RFI Response – Crescent Parklands, Holroyd (SSD-70283710)

This letter relates to State Significant Development Application SSD-70283710 for the proposed mixed-use precinct development, including seven residential tower buildings, an eastern mixed-use podium and associated car parking at 1 Crescent Street, Holroyd (**the site**).

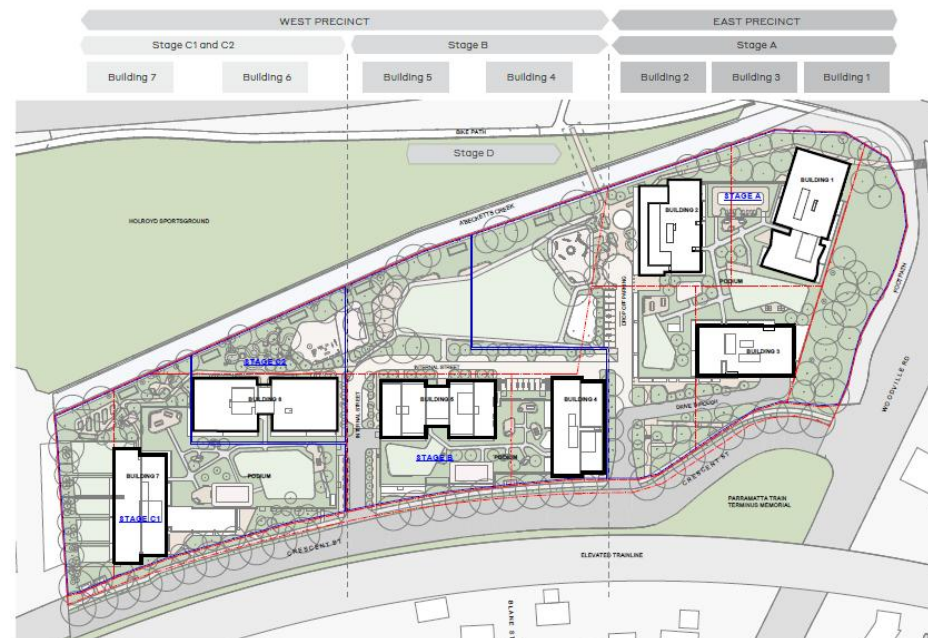
DPHI Comments	Response								
Staging Strategy The Department requests that you provide clarification regarding the proposed staging strategy, noting that the strategy set out in Table 6 (comparative analysis) and Section 3.4.2 of the SAR is inconsistent with Appendix NN. You must clarify which strategy is proposed and provided an updated comparative analysis table and staging assessment, where relevant.	The comparative analysis table below has updated to reflect the information contained in the Staging Strategy (Appendix NN). <table><tr><th>COMPONENT</th><th>SSD PROPOSAL AS LODGED (JANUARY 2025)</th><th>AMENDED PROPOSAL (NOVEMBER 2025)</th><th>VARIANCE</th></tr><tr><td>Staging</td><td>Phase 1 - Buildings 1, 2 and 3 Phase 2 - Buildings 4 and 5 Phase 3 - Buildings 6 and 7</td><td>Stage A0 – Early Enabling Works Stage A - Buildings 1, 2 and 3 Stage B - Buildings 4 and 5 Stage C - Buildings 6 and 7 Stage D - Bridge</td><td>Amended to provide: - Further detail on staging - Flexibility to allow varied sequencing (between Stages A, B and C) - Separate Stage for the Bridge (Stage D)</td></tr></table> Section 3.4.2 of the SAR in relation to Development Staging and Early Works has been updated below to reflect what is in the Staging Strategy in Appendix NN. Summary of Development Staging The Crescent Parklands development is proposed to be delivered in three primary stages (A, B and C), together with:	COMPONENT	SSD PROPOSAL AS LODGED (JANUARY 2025)	AMENDED PROPOSAL (NOVEMBER 2025)	VARIANCE	Staging	Phase 1 - Buildings 1, 2 and 3 Phase 2 - Buildings 4 and 5 Phase 3 - Buildings 6 and 7	Stage A0 – Early Enabling Works Stage A - Buildings 1, 2 and 3 Stage B - Buildings 4 and 5 Stage C - Buildings 6 and 7 Stage D - Bridge	Amended to provide: - Further detail on staging - Flexibility to allow varied sequencing (between Stages A, B and C) - Separate Stage for the Bridge (Stage D)
COMPONENT	SSD PROPOSAL AS LODGED (JANUARY 2025)	AMENDED PROPOSAL (NOVEMBER 2025)	VARIANCE						
Staging	Phase 1 - Buildings 1, 2 and 3 Phase 2 - Buildings 4 and 5 Phase 3 - Buildings 6 and 7	Stage A0 – Early Enabling Works Stage A - Buildings 1, 2 and 3 Stage B - Buildings 4 and 5 Stage C - Buildings 6 and 7 Stage D - Bridge	Amended to provide: - Further detail on staging - Flexibility to allow varied sequencing (between Stages A, B and C) - Separate Stage for the Bridge (Stage D)

Each stage corresponds to a logical development cluster and will deliver all necessary remediation, infrastructure and public domain works to allow for independent operation

The indicative staging of development is summarised in the following table.

STAGING	LOCATION	INCLUSIONS
Stage A0	Early Enabling Works	
Stage A	East Precinct	• Buildings 1, 2 and 3 (including podium) • Road access, including part of the internal road • Part of the central area of open space • TfNSW easement • Crescent Street Road widening
Stage B	Central Precinct	• Buildings 4 and 5 (including podium) • Part of the internal road • Part of the central area of open space
Stage C	West Precinct	• Buildings 6 and 7 (including podium) • Landscaping, and part of the open space • Part of the internal road
Stage D	Bridge	• Pedestrian/cycle bridge over A’Becketts Creek
